CBSS RFI 605-01
Please Advise

NO.	DATE	REMARKS	BY
REVISIONS			
CASCO BAY STEEL		CASCO BAY STEEL STRUCTURES	
STRUCTURE		BENMONT AVE. (TH-7) (URBAN MINOR ARTERIAL)	
LOCATION		TOWN OF BENNINGTON, VERMONT	
PROJECT NO.		BRIDGE NO. 57 PROJECT NO. BRF 1000(16)	
ENGINEER		STATE OF VERMONT AGENCY OF TRANSPORTATION	
CUSTOMER		ALPINE CONSTRUCTION	
ITEM		LAYOUTS	
SURFACE PREP.		OPEN HOLES 1/8" HOLES FOR 3/4" BOLTS	
PAINT			
APPROVAL	DRAWN WCG 12-2-14	SHEET NO.	JOB NO.
SHOP	CHECKED LK 12-3-14	TD2	605

**WATERLINE UTILITY SUPPORT
BETWEEN GIRDERS 1 & 2
(LOOKING UPSTATION)**

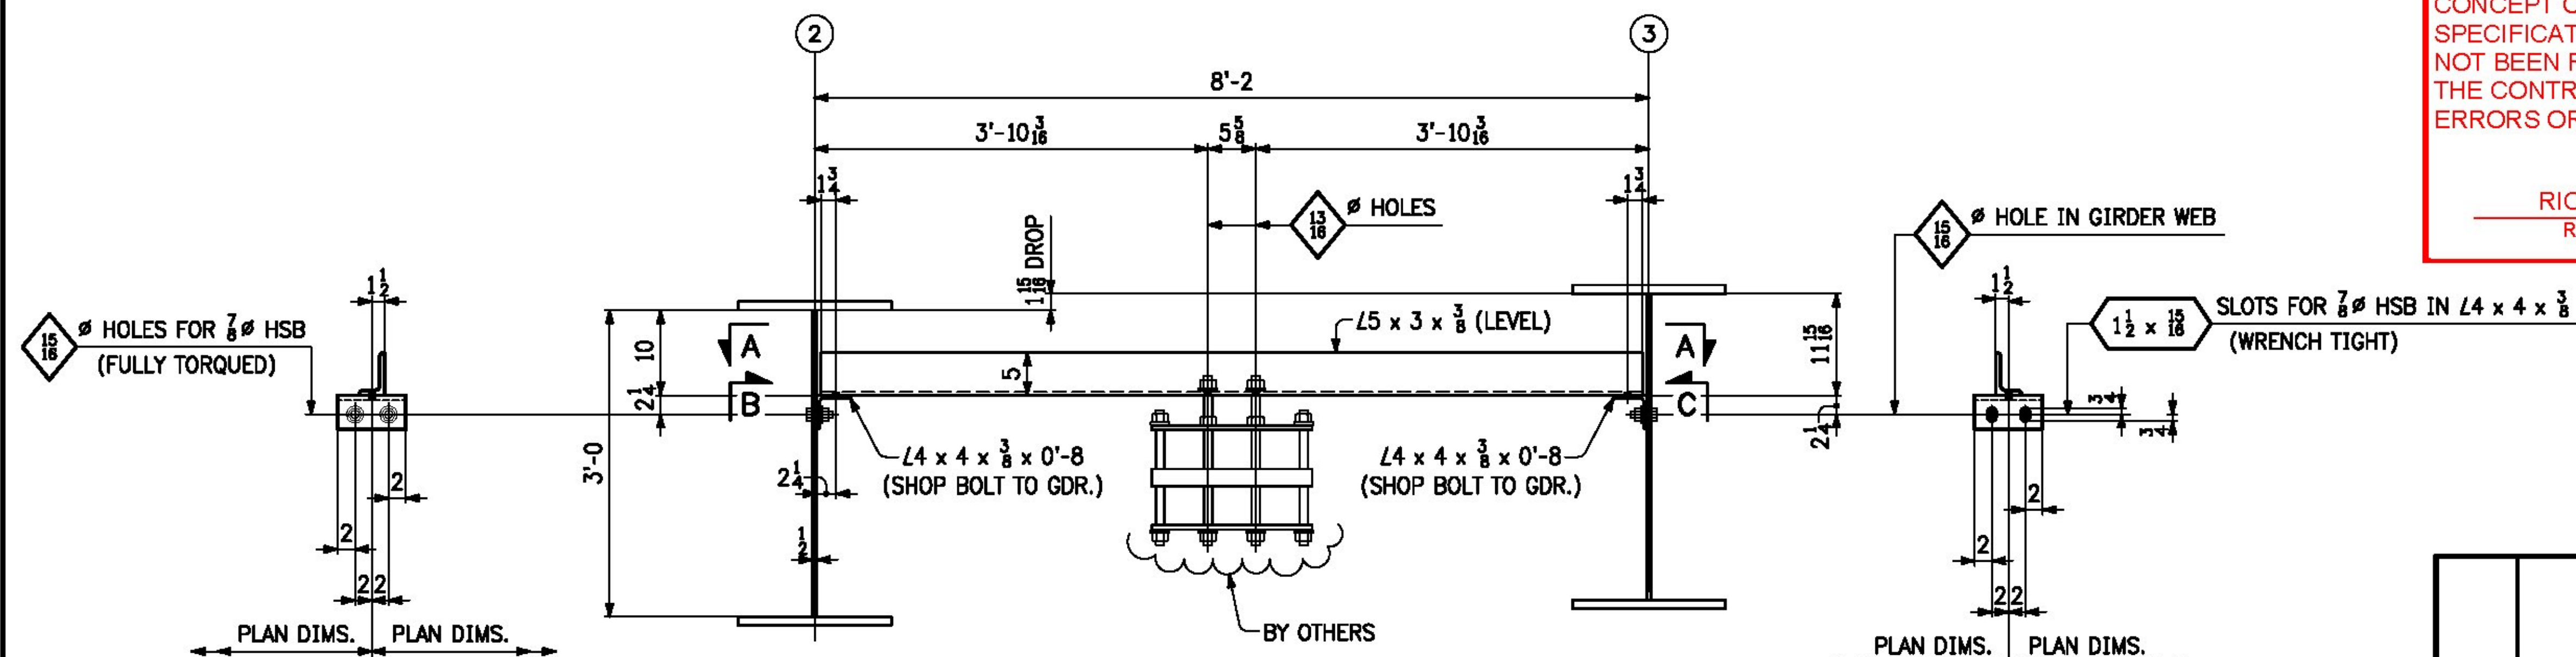
Shop weld connection
angle to web and field
bolt W8 to connection
angles

Shop weld connection
angle to web

- APPROVED
- APPROVED AS NOTED
- REVISE AND RESUBMIT
